Staff Report Harrisburg Planning Commission Harrisburg, Oregon

THE MATTER OF THE WOODHILL CROSSING PRELIMINARY 31-LOT SUBDIVISION APPLICATION (LU 424-2020)

LOCATION: 930 Summerville Loop, Harrisburg, Oregon 97446

Sheet **C 2.0**
 SCALE: SEE BARSCALE

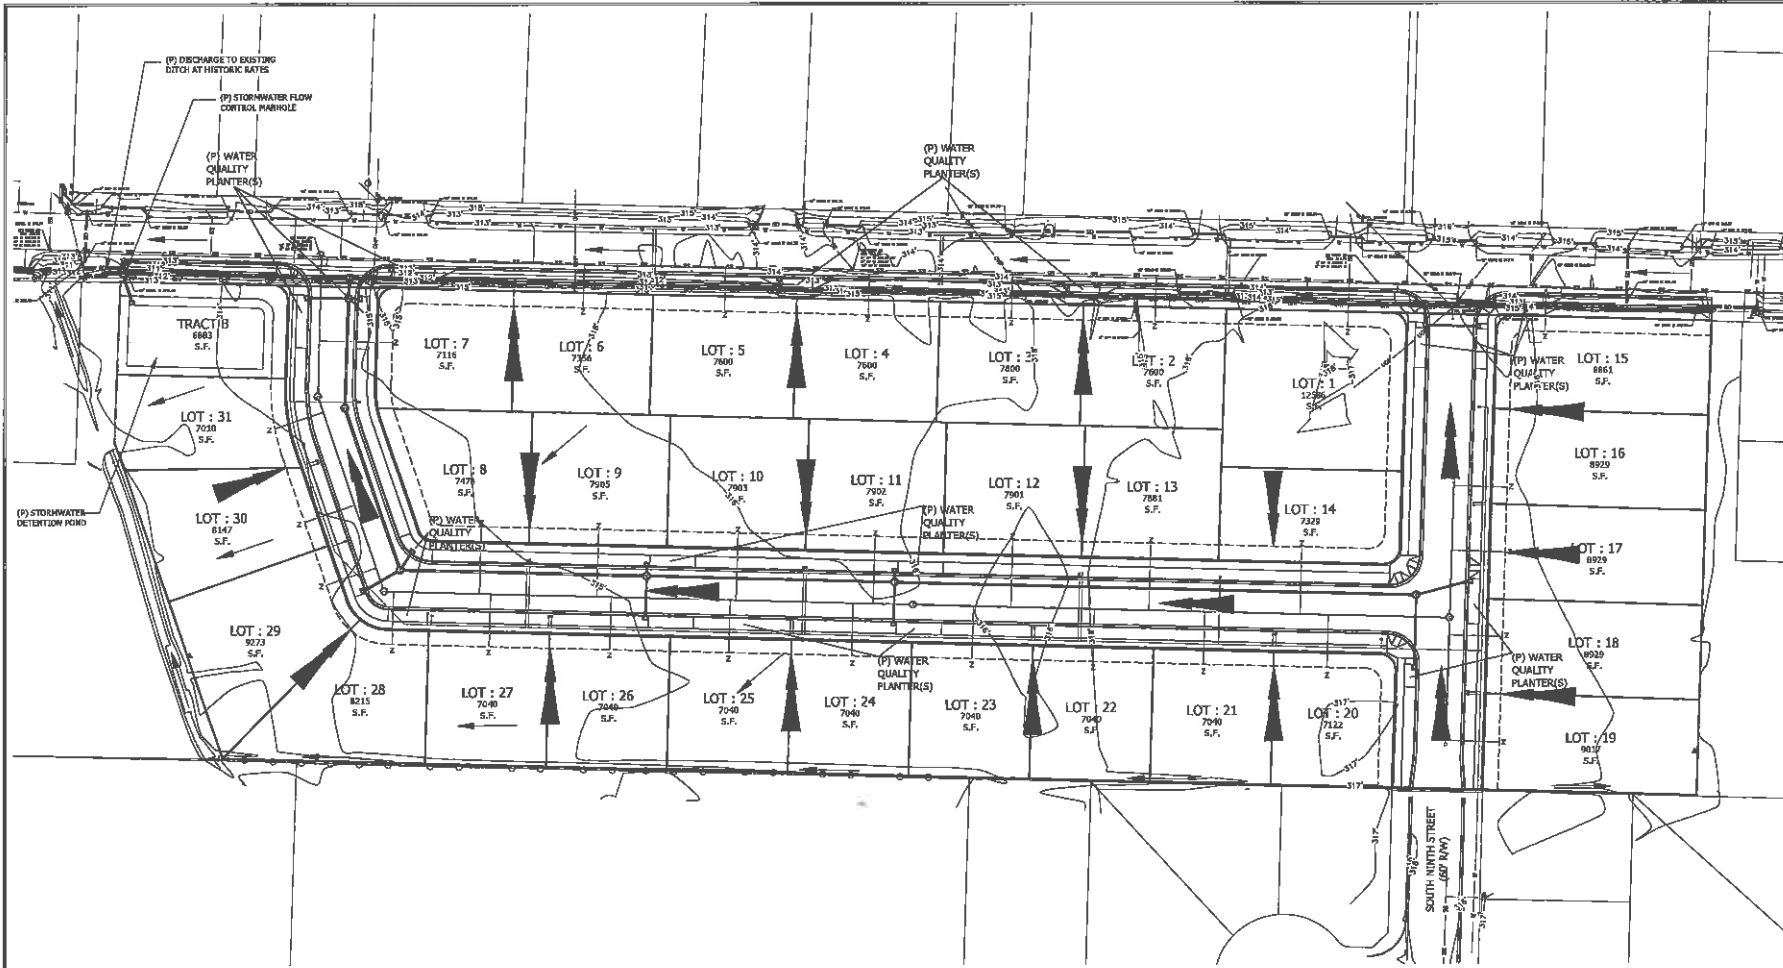
The Fire Chief has asked for the fire hydrant located on the southwest corner of the right-of-way adjacent to lots 27 and 28, to be moved to the east, to be located adjacent to the lot lines on lots 25 and 26. The developer shall show this location change on the revised plat (**Condition 8**). As conditioned, this requirement has been met.

8. **Fire Hydrants** – Prior to Final Plat approval, the preliminary plat shall be revised to show the fire hydrant location to be moved from between lots 27 and 28, to the location between lots 25 and 26. The type and locations of Fire Hydrants will be approved by the Fire Chief and the Public Works Director.
